## Determination 2010/051

### Refusal to issue a code compliance certificate for a 10-year-old house with monolithic cladding at 3/134 Birkenhead Avenue, North Shore

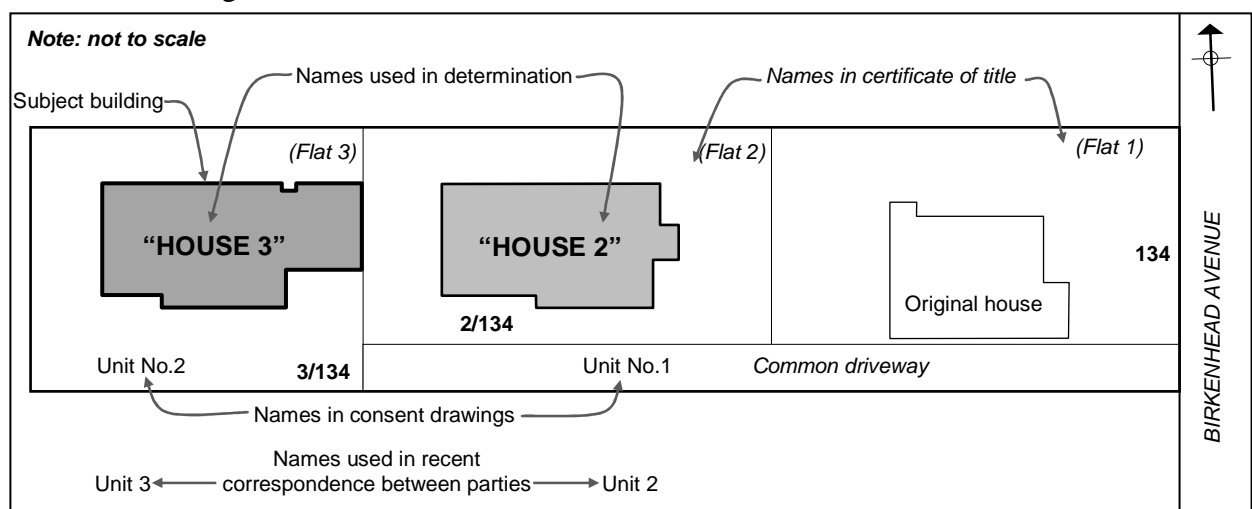
2.1 House 3 is one of three houses situated on a steep west-sloping site as shown in the following sketch:
